CNL-17-100

Clinch River Nuclear Site
NRC Docket No. 52-047

Subject: Response to Request for Additional Information Number 5, Questions 02.05.01-03 and 02.05.01-05, Regarding Basis Geologic and Seismic Information in Support of Early Site Permit Application for Clinch River Nuclear Site

Enclosure 1
Response to NRC RAI Number 5, Question 02.05.01-03

Figure 2.5.1-86 (Sheet 1 of 7) Seismic Tomography Model SRS-1

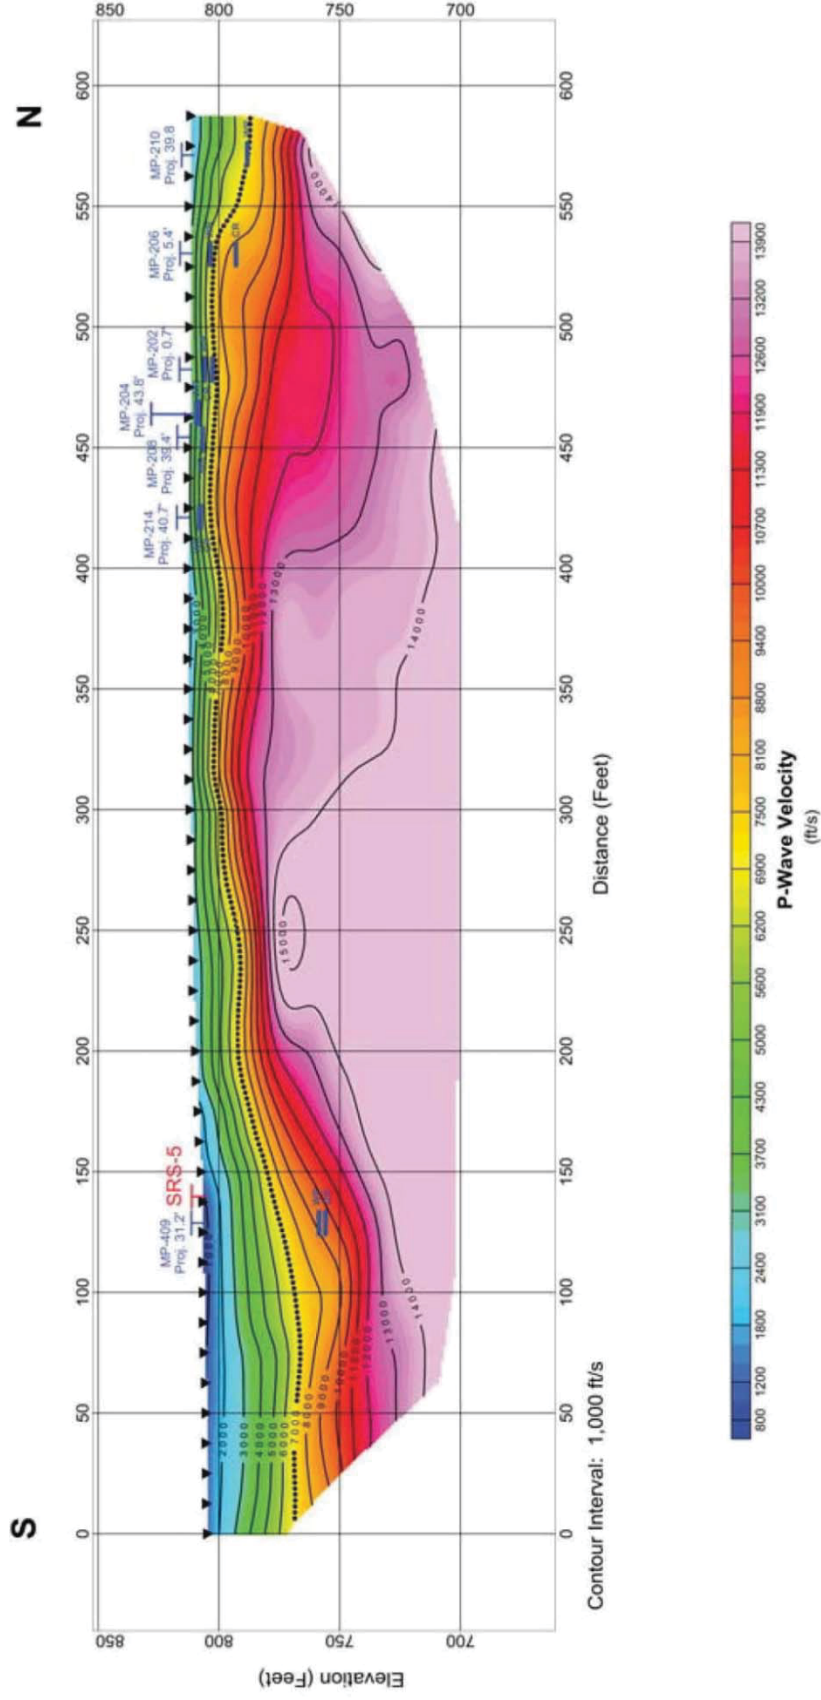
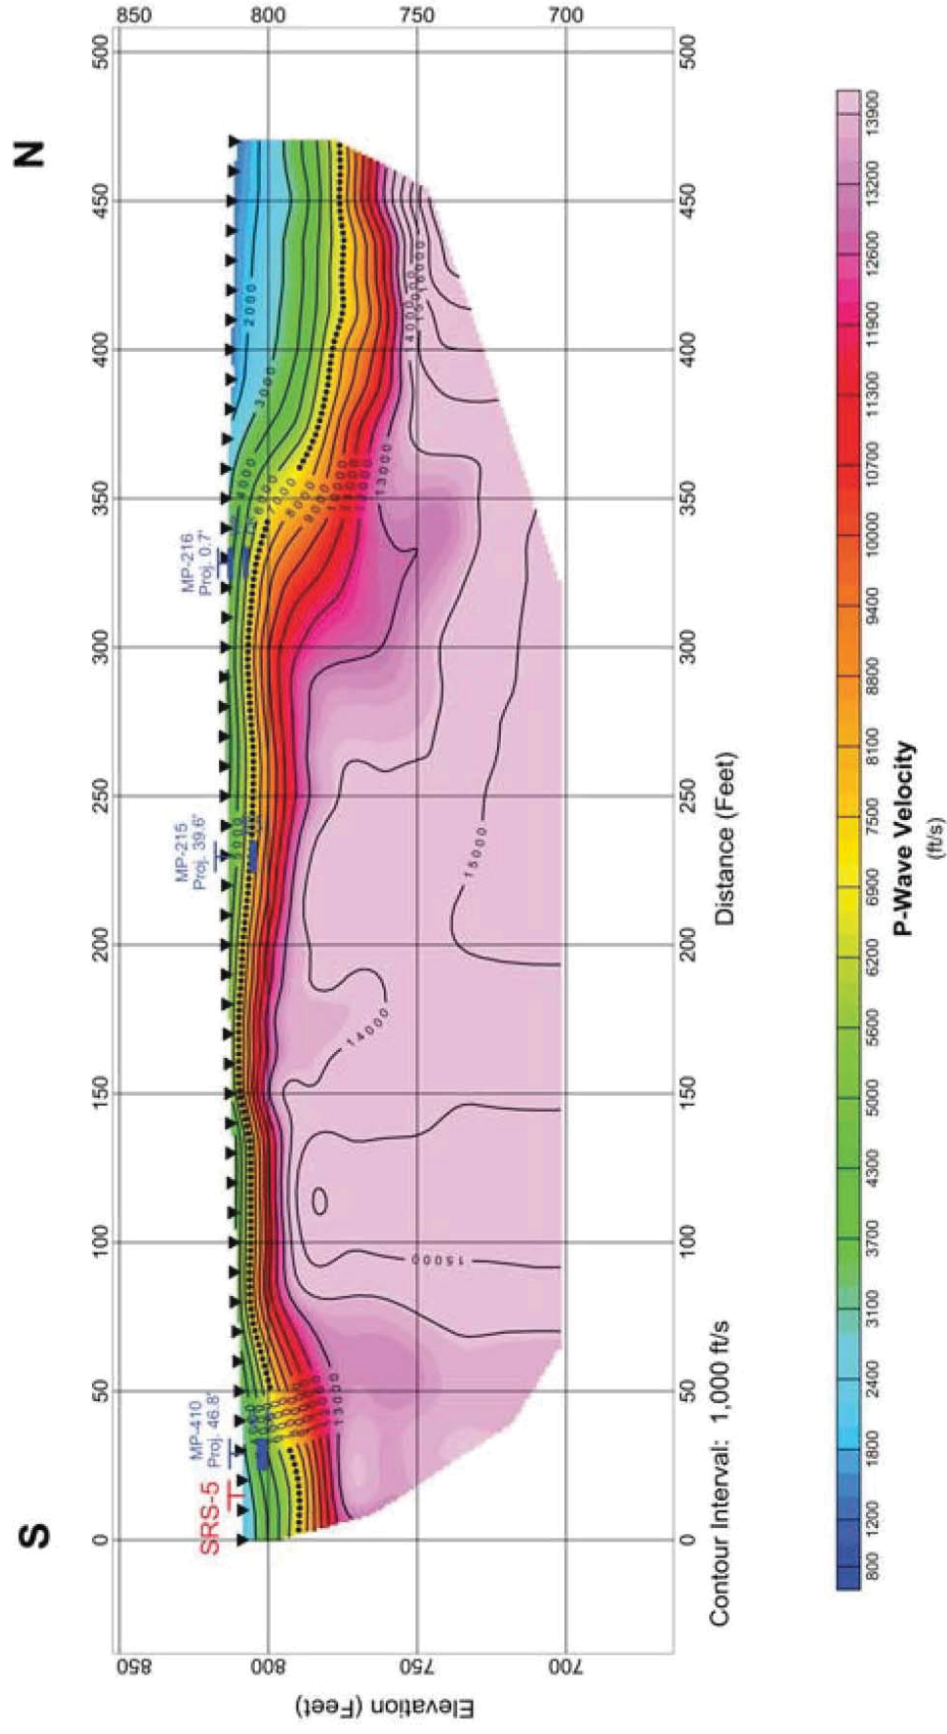
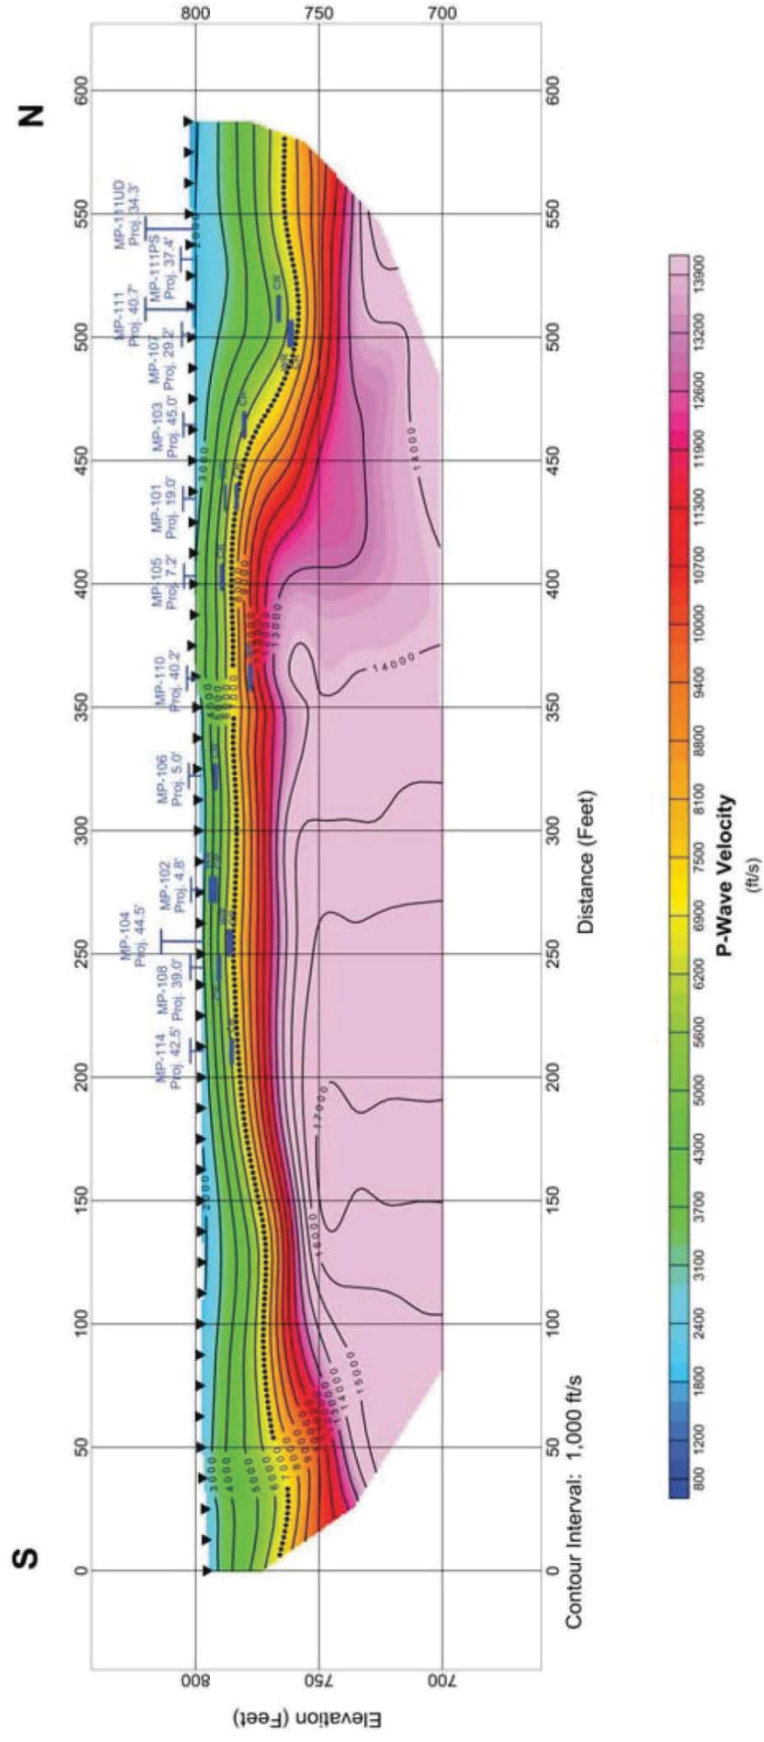
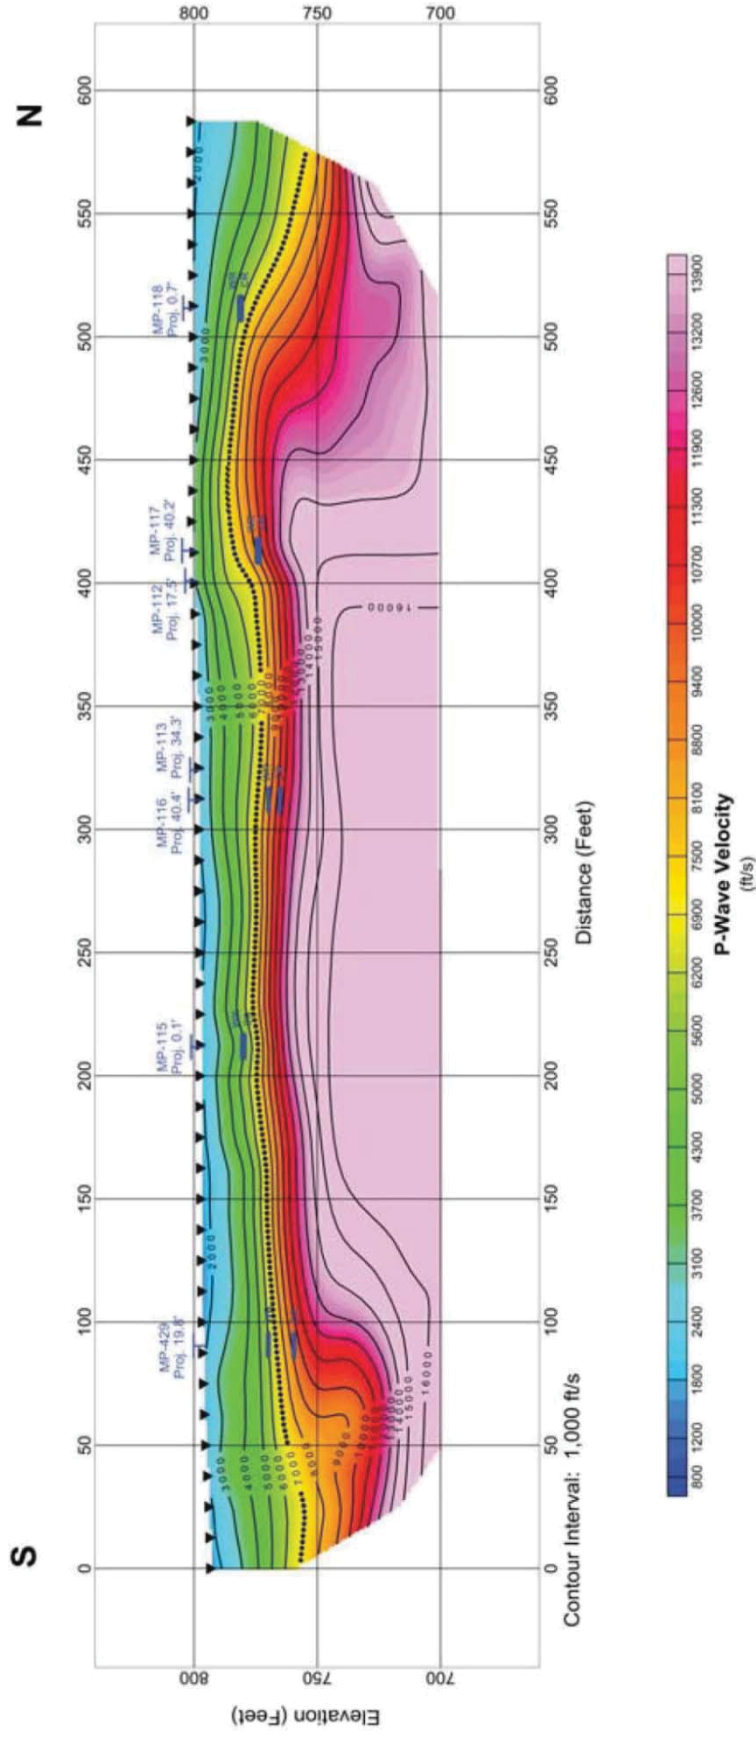
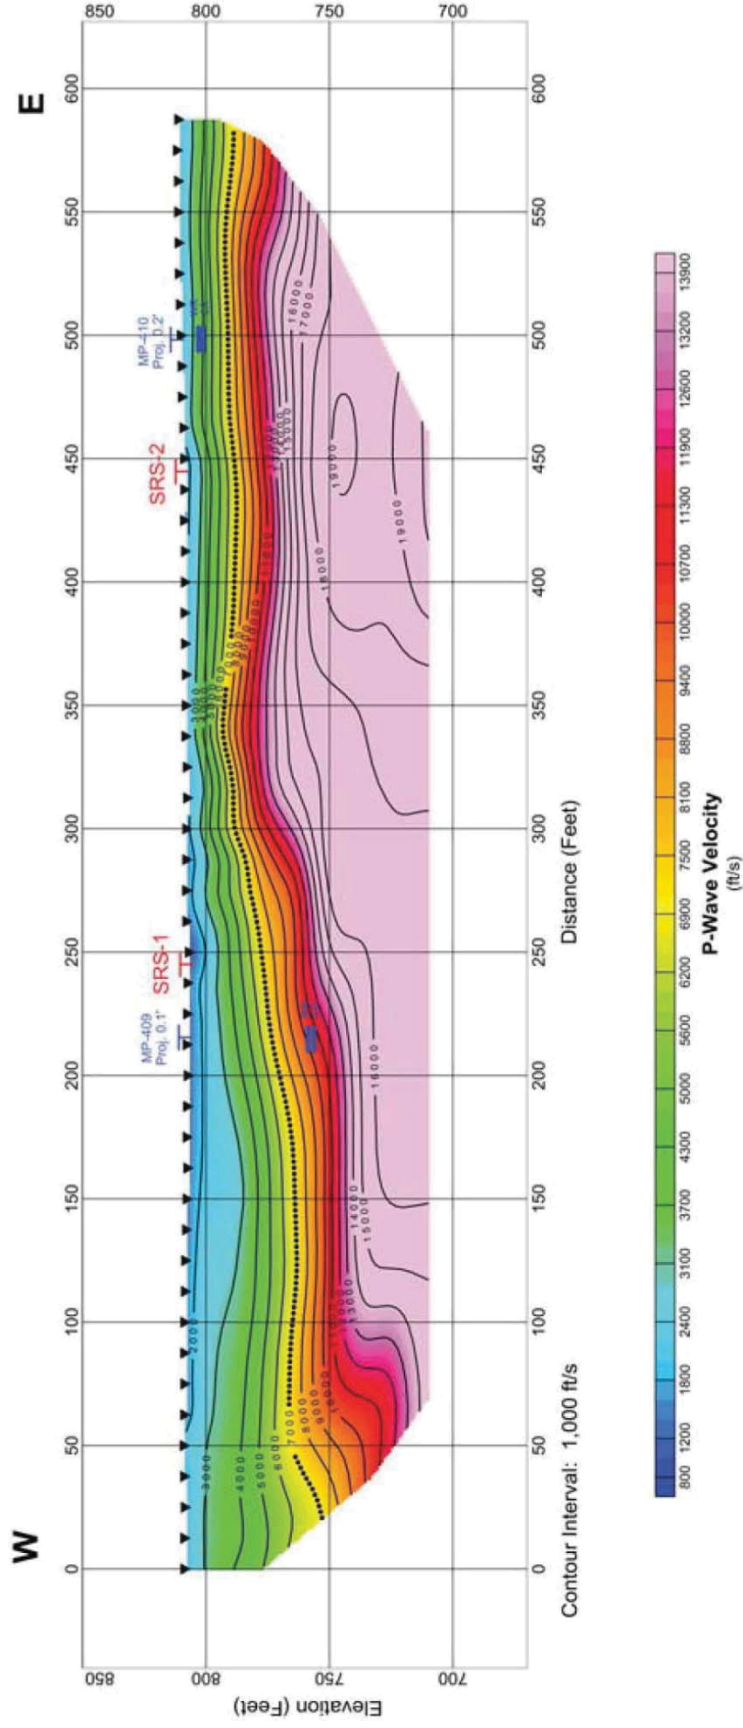
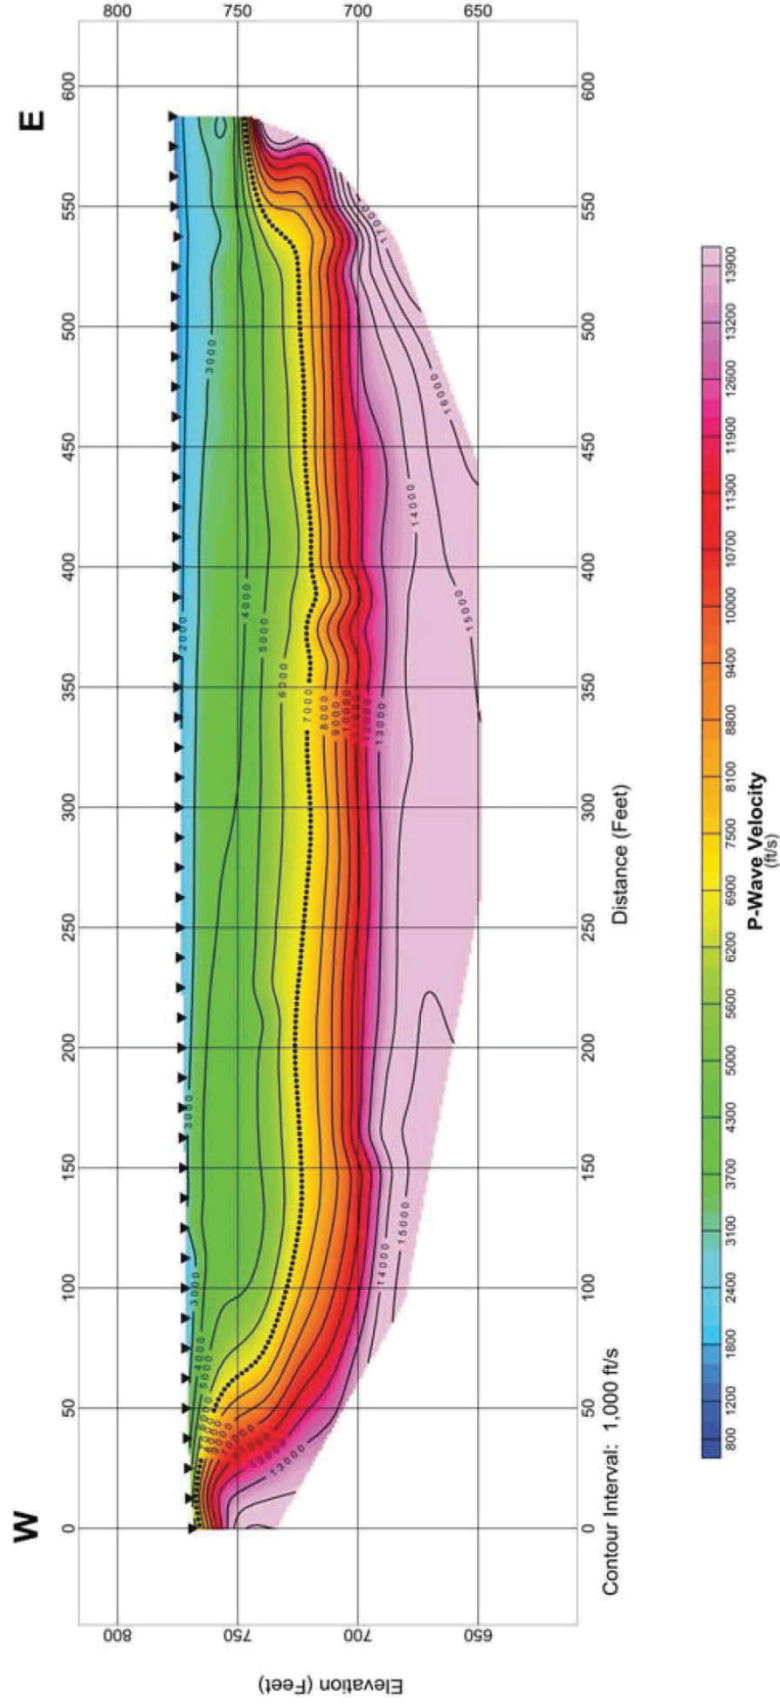
- a. SSAR (Rev 0) 2.5.3.2.3 Karst, indicates that seismic refraction surveys at the site were used to characterize carbonate dissolution features. Because no data were presented in the SSAR (Rev 0) regarding the characterization of the seismic refraction surveys, please discuss the specific evaluation of the seismic refraction data with respect to detecting carbonate dissolution features.*

- a. The primary objective of the seismic refraction surveys was to map the depth to bedrock at the Clinch River Nuclear (CRN) Site, although these data were also reviewed to potentially identify subsurface karst features. As discussed in SSAR Subsection 2.5.1.2.5.1.2, the seismic refraction data are not effective in terms of assessing the presence or absence of karst features, primarily because the lines were collected in areas that had been graded during Clinch River Breeder Reactor Project (CRBRP) activities in the 1970s and 1980s. In some places, significant thicknesses of bedrock had been removed and a thin layer of fill emplaced over the graded bedrock surface. In other places, thick fill had been emplaced to backfill the 1983 excavation or to fill small valleys. The seismic refraction profiles primarily show the extent of fill and depth to bedrock.*

The seismic refraction tomography profiles are being added to the SSAR as figures, and a description of the methods of data collection are being added to SSAR Subsection 2.5.1.2.4.2.1 as indicated in the SSAR markups below. A discussion of the significance of the seismic refraction data to the assessment of karst was previously included in SSAR Subsection 2.5.1.2.1.5.2, and is being revised as indicated in the SSAR markups below to amplify the discussion and refer to the new figures. The SSAR markups will be incorporated in a future revision of the early site permit application.

Six seismic refraction lines were acquired at the CRN Site (Figure 2.5.1-29). The data are presented as seismic tomography models (Figure 2.5.1-86). Such models can be used to resolve complex velocity structure that cannot be imaged using layer-based modelling techniques (Reference 2.5.1-214). The primary objective of the seismic refraction surveys was to map the depth to bedrock in graded and filled areas within the central portion of the site. The data were also reviewed to identify anomalies that might indicate the presence of geologic structures such as blind faults or large karst dissolution features beneath the fill. The resolution of these data is not sufficient to identify small-scale features (less than 10 ft). The results of this review are presented in Subsection 2.5.1.2.5.1.2.

Seismic refraction tomography surveys are useful to image near-surface karst features such as an irregular top of bedrock and shallow cavities (References 2.5.1-255 and 2.5.1-256). This method and other geophysical methods are often used in karst terrain to complement borehole analysis. A seismic refraction tomography survey, consisting of six lines, each 500 to 600 ft in length, was conducted at the site to map depth to rock (Figure 2.5.1-29) (Reference 2.5.1-214). These surveys were conducted primarily in areas that had been graded as part of CRBRP construction activities. The soil and rock under the high points had been removed, and fill had been emplaced in the low points to create a planar ground surface. The resulting tomography models, therefore, primarily delineate the top of bedrock and the margins of the fill (Figure 2.5.1-86). The seismic refraction tomography profiles show the general shape of the top-of-rock. Where they can be correlated, the borehole top-of-rock corresponds to a compressional wave velocity (V_p) of 7,000 fps to 11,000 fps. The thickest fill is shown on Figure 2.5.1-86, Sheet 6, along line SRS-6 located within the 1983 CRBRP excavation. Here, the bottom of the excavation at 712.5 ft MSL corresponds to a V_p of about 11,000 fps. No features were observed in the seismic refraction data that could clearly be attributed to karst phenomena.

In addition to analysis of the ground surface, seismic refraction tomography surveys profiles were ~~conducted~~ reviewed to possibly identify features related to carbonate dissolution in the shallow subsurface (Reference 2.5.3-3) (see Figure 2.5.1-86). ~~These~~ Seismic refraction surveys were conducted ~~primarily~~ in areas that had been graded as part of CRBRP construction activities to map the depth of bedrock (Reference 2.5.3-3). The deep excavation of the site had
